Studio 5/7 Pop Pin Change and S/N Matrix

Studio 5 (9-7280) + Studio 7 (9-7290)

Customer Services Bulletin

Frame Type	Pop Pin
<p>Frame A</p> <p>NOTE: 740-8981 and 718-5749 are interchangeable.</p>	 <p>740-8981</p>
<p>Frame A</p> <p>NOTE: 740-8981 and 718-5749 are interchangeable.</p>	 <p>718-5749</p>

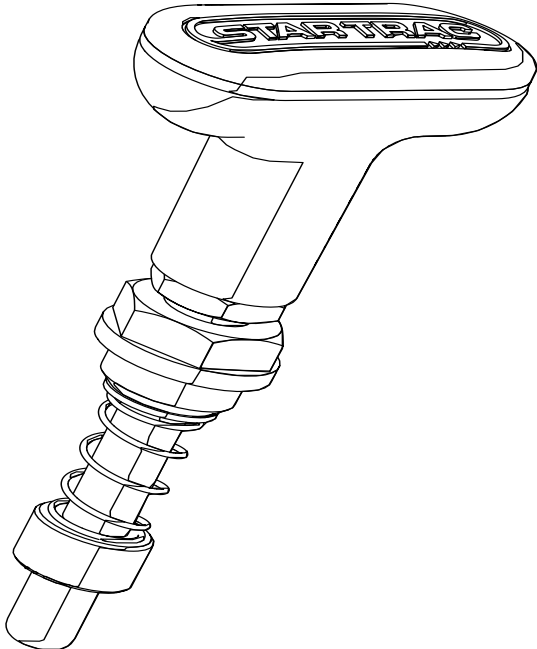
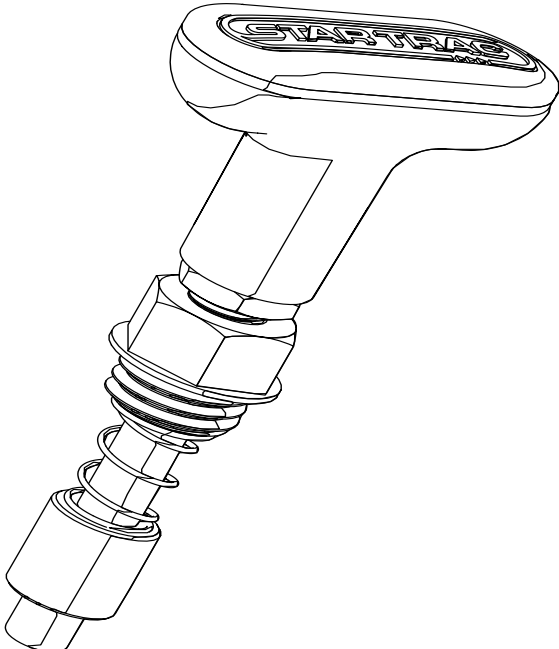
In Q1/Q2 2017, there were several changes to the frames of the Studio 5 and Studio 7 cycles to accommodate newly designed pop pins.

Please be aware that depending on the serial number, the Studio 5 and Studio 7 cycles could use one of two different pop pins.

Please note that 740-8981 and 718-5749 are interchangeable.

Frame B

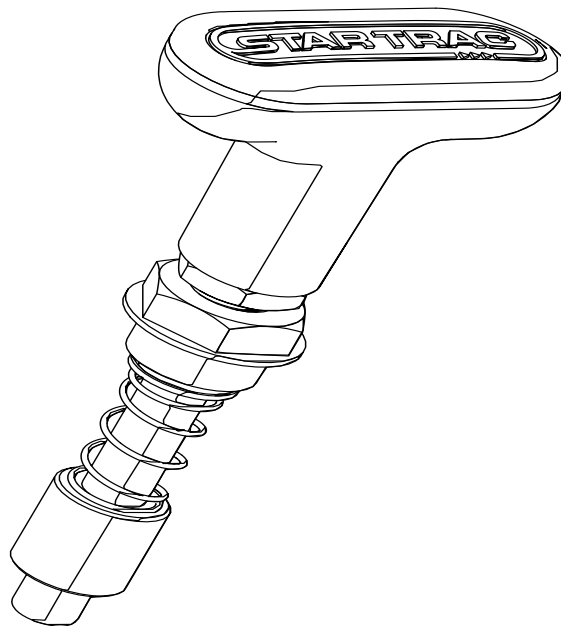
718-5741

Frame B

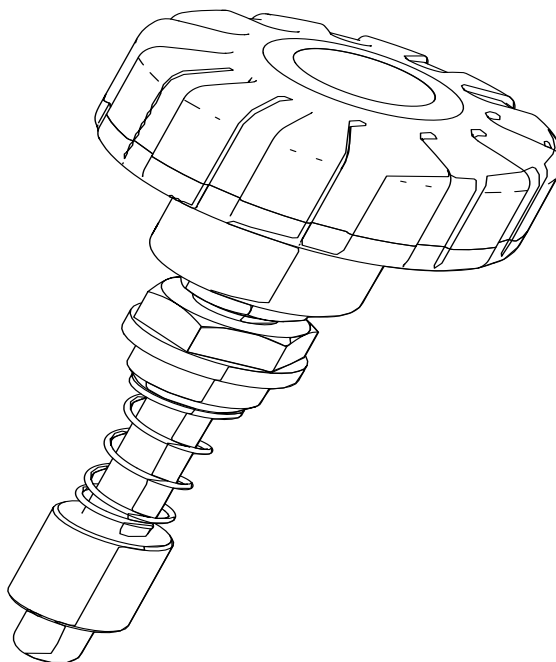
740-9201
